**RE: Memorial Regional Hospital OR Expansion
3501 Johnson Street Hollywood, Florida
TAC File # 24-DP-38
TAC Sign Off Review RAI Response Letter**

DIVISION OF PLANNING AND URBAN DESIGN, 24-DP-38 (Cameron Palmer, Principal Planner)

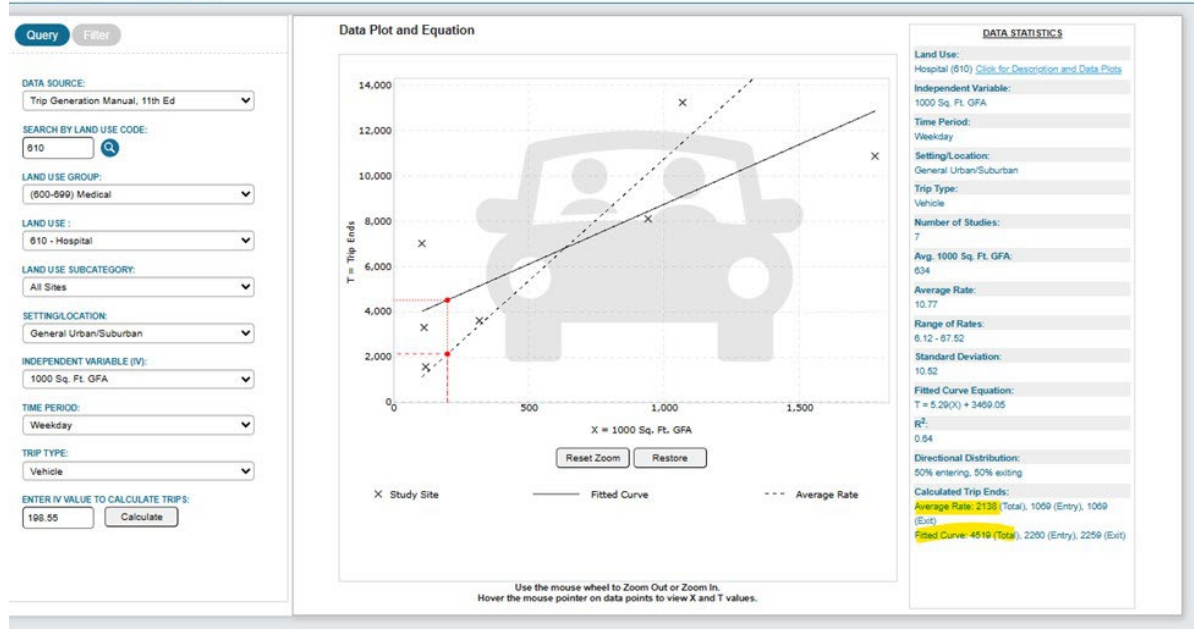
2. Figure 2 – The northbound and southbound approaches of the intersection of N Park Road/Garfield Street should be revised to include one shared left-turn/through lane plus one shared through/right-turn lane. The left-turn movement is missing, and it is an allowed movement.

Response: Revised. See updated Traffic Study attached.

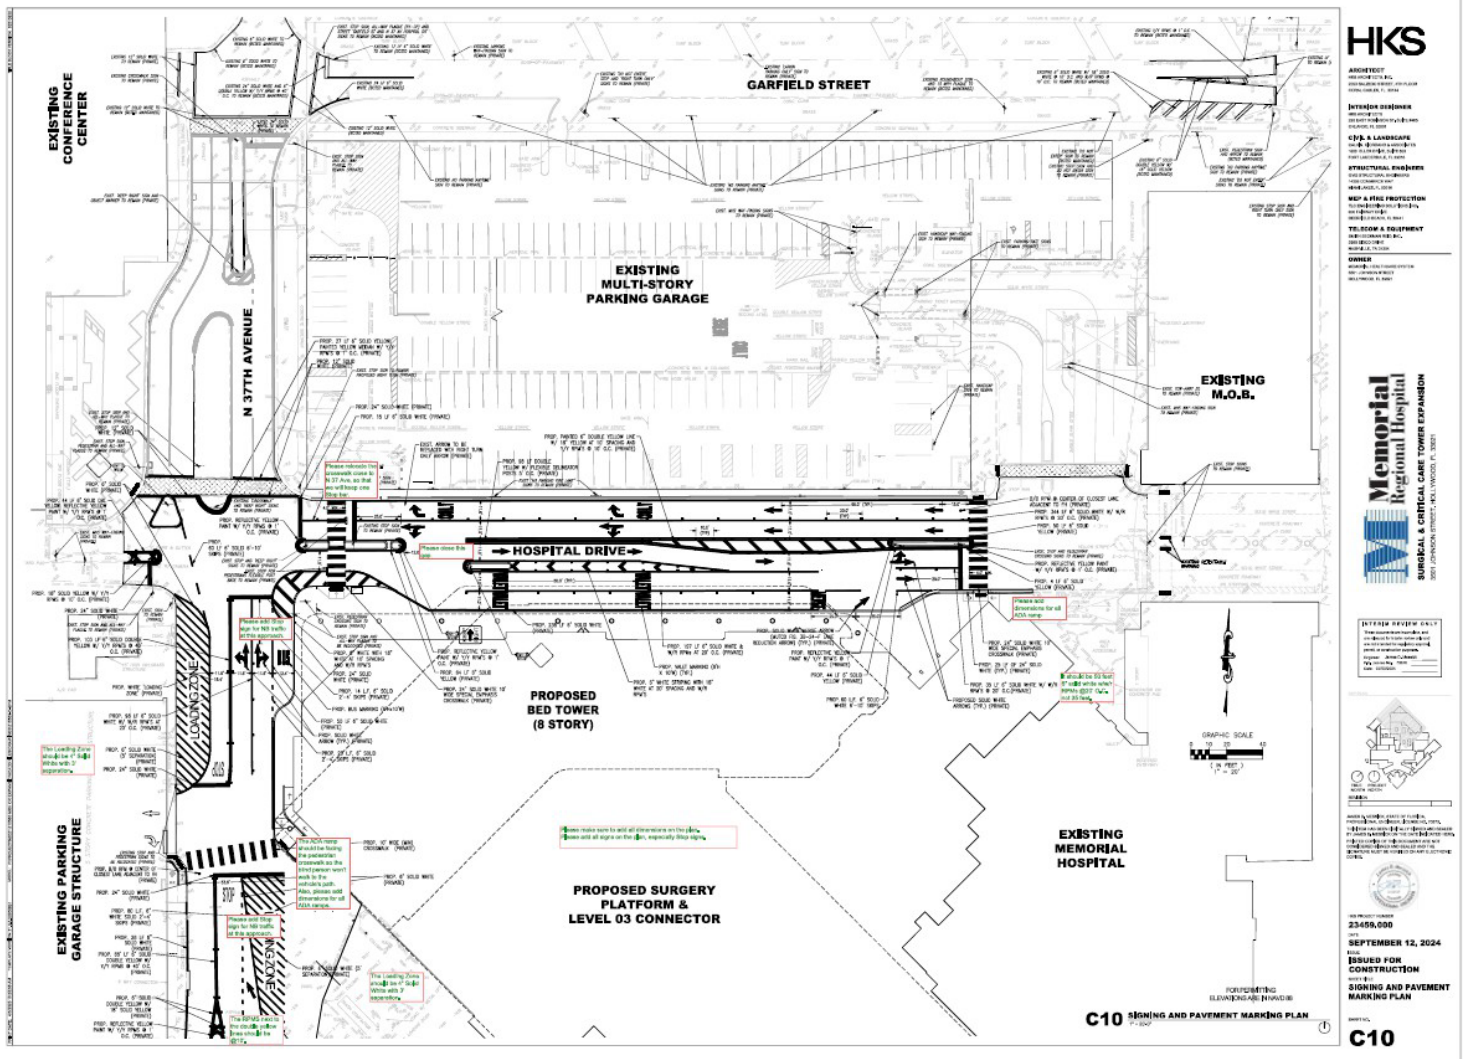
- c) Evaluation of the need for a traffic signal at the intersection of Johnson Street and access to the parking garages with the proposed expansion.

Response: A separate study is being prepared to evaluate the need for a traffic signal at the intersection of Johnson Street and the access to the parking garages in relation to the proposed expansion.

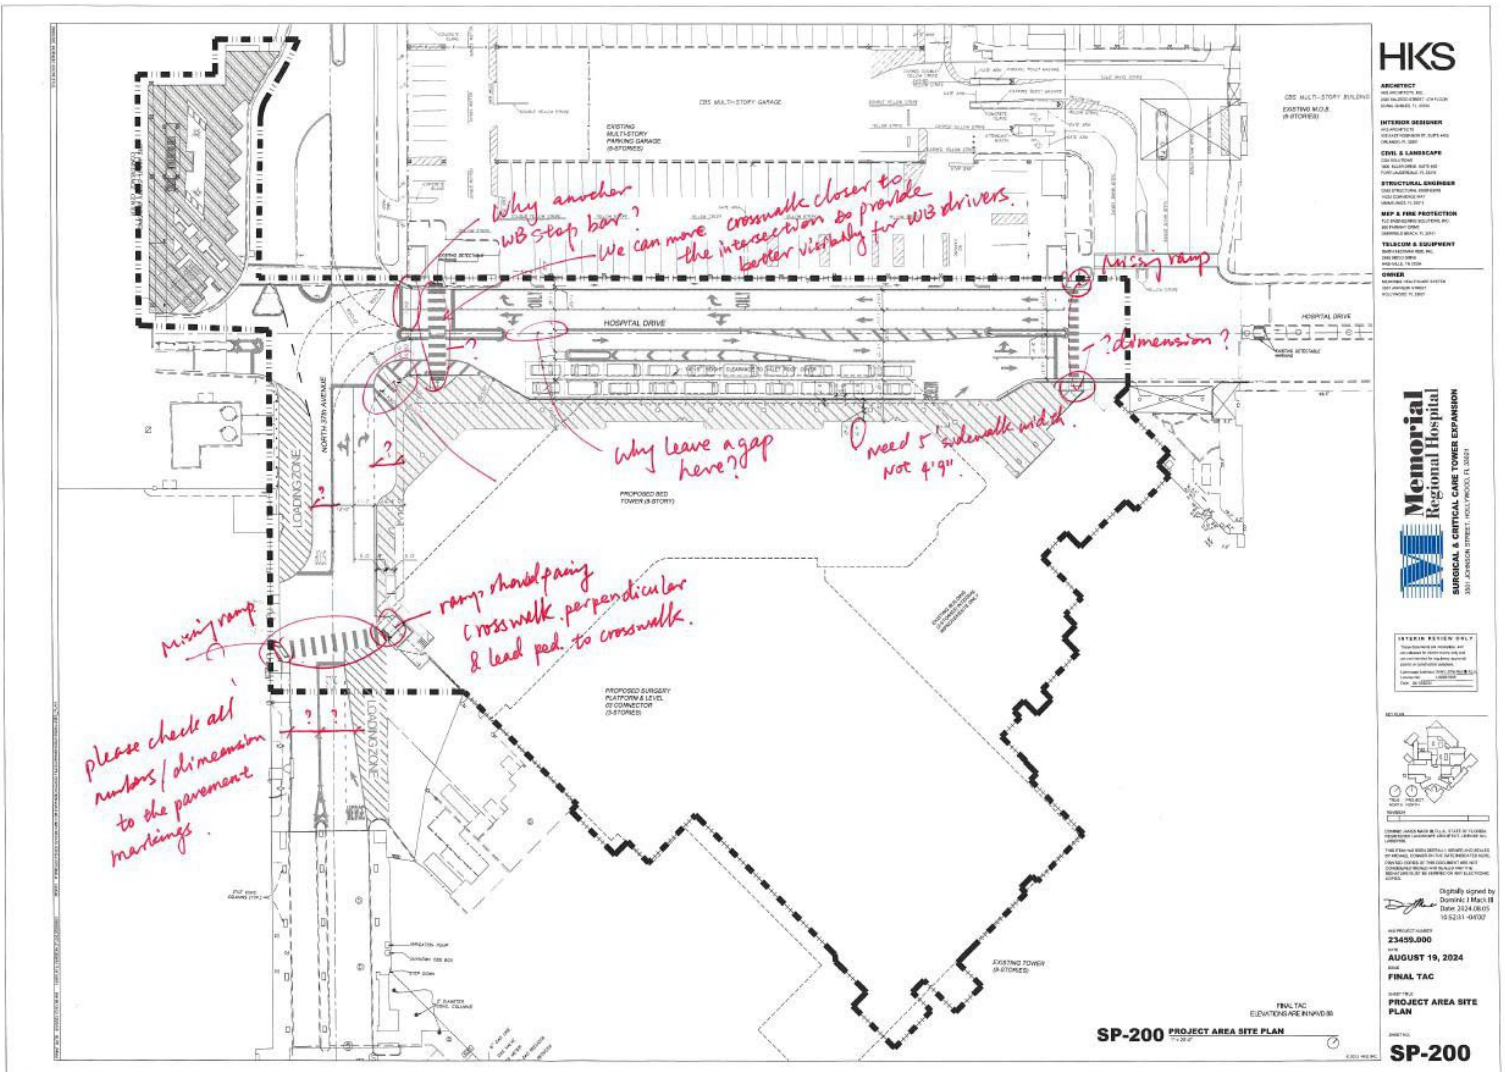
10. The RPMs next to the double yellow lines should be @ 10'.
CGA Response 12/18/2024: Please note that FDOT Index 700-001 requires RPMs to be spaced at 40' for double solid lines. A 10' spacing is used for traffic separators.

11. Please make sure to add all dimensions of the plan. Please add all signs on the plan, especially Stop signs.
CGA Response 12/18/2024: Noted. Dimensions and signs will be added to the plans.

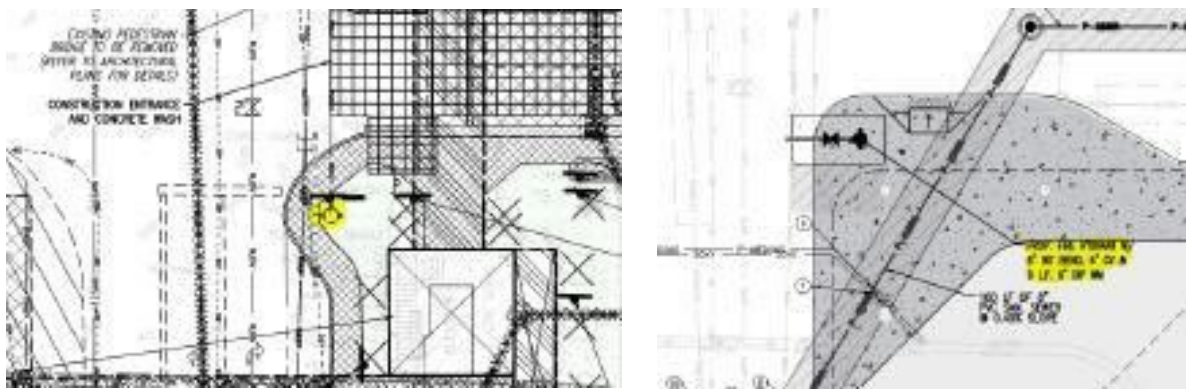
*Reviewer Response: COMMENT PARTIALLY ADDRESSED: Note added onto Utility Plan Sheet C06 states 'Water and Sewer demands for this project have been calculated by the MEP Engineer to be 430 GPM', but no calculations were shown to substantiate. Please clarify if this is only for the addition. Verify $430 \text{ GPM} = 619,200 \text{ GPD}$. ***

Response: Building expansion water consumption is estimated at an average of 450 gallons per minute. Calculation is based on plumbing fixture units accounting for usage diversity. The building expansion air conditioning is estimated to increase cooling tower make up water consumption by approximately 50 gallons per minute. Combined average consumption increase is estimated at 500 gallons per minute. See attached Building Expansion Water Consumption Calculations to substantiate demand calculations.

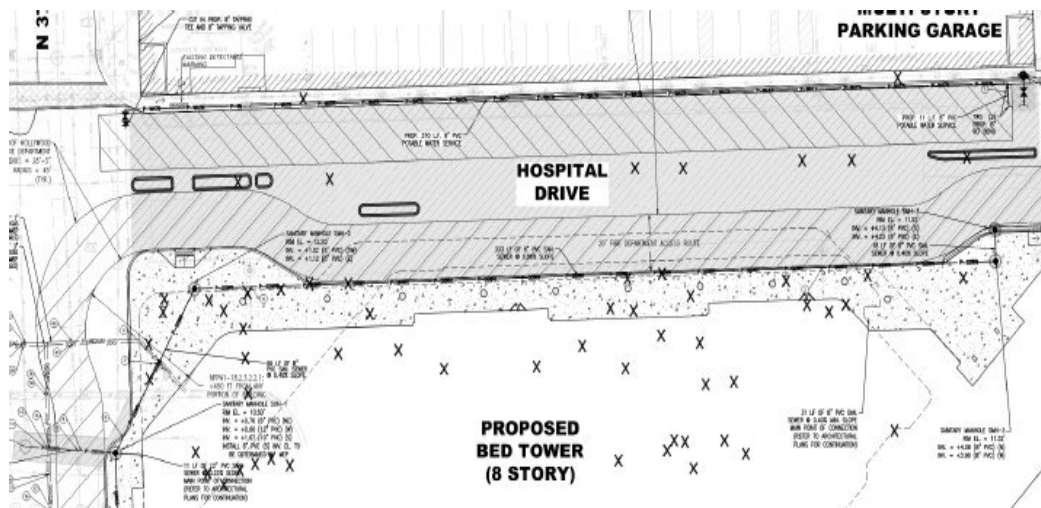
1. Sheet C-6: Verify layers to be displayed.

Response: See sheet C06 which has been revised to clean up layer issue.

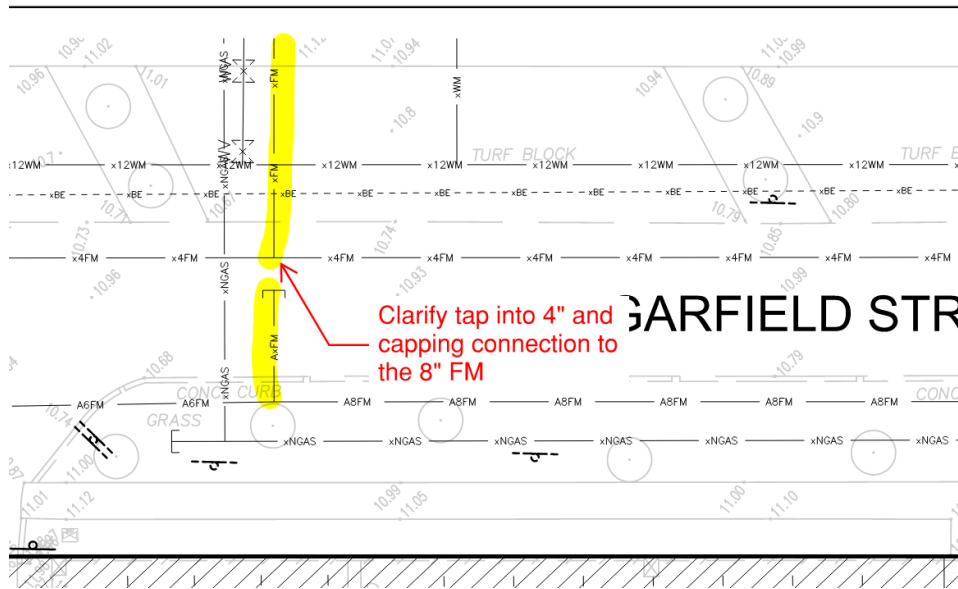
A. Sheet C-02: Clarify FM capping along Garfield Street per snapshot below.

Response: Please see sheet C02 which now shows existing sewers service connection to existing 6" FM based on existing conditions.

Survey – Sheet S-5

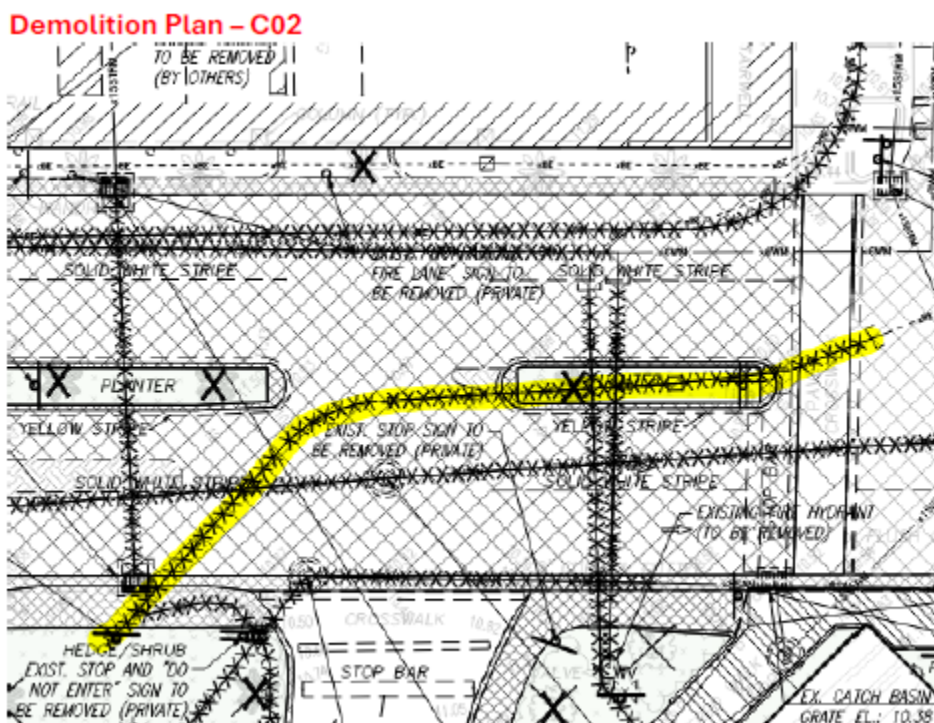
B. Based on review of the Alta Survey and Civil Plans, there is an existing FPL easement along Hospital Drive on Alta Survey Sheets S-4 and S-5. It appears that the existing FPL underground service line is capped as shown on the Demolition Plan Sheet C02. Sheet C03 shows proposed drainage traversing the existing FPL easement. Clarify if FPL easement is being vacated.

Response: The applicant MEP engineer has been reviewing the electrical needs with the FPL service planners during review of construction plans. Any construction that requires relocating existing FPL facilities are being addressed during the construction plan review period to avoid premature releases and dedications. During this time FPL will instruct the applicant of the method and timing of releasing existing easements and the dedication of new easements, which may occur before, during or after construction (as-built release and dedications). Since the subject easement is a direct easement with FPL, FPL will provide the applicant the necessary documents to execute, and the applicant or FPL will provide the necessary sketch and descriptions for recording said release and dedication(s). The release and dedication of direct FPL easements does not

require a vacation process through the City of Hollywood or Broward County; however the City Utilities Division can be kept abreast of the issue during this review and construction process. The underground line cited above is expected to require said release as part of FPL's overall review of existing easements, relocations and new dedications.
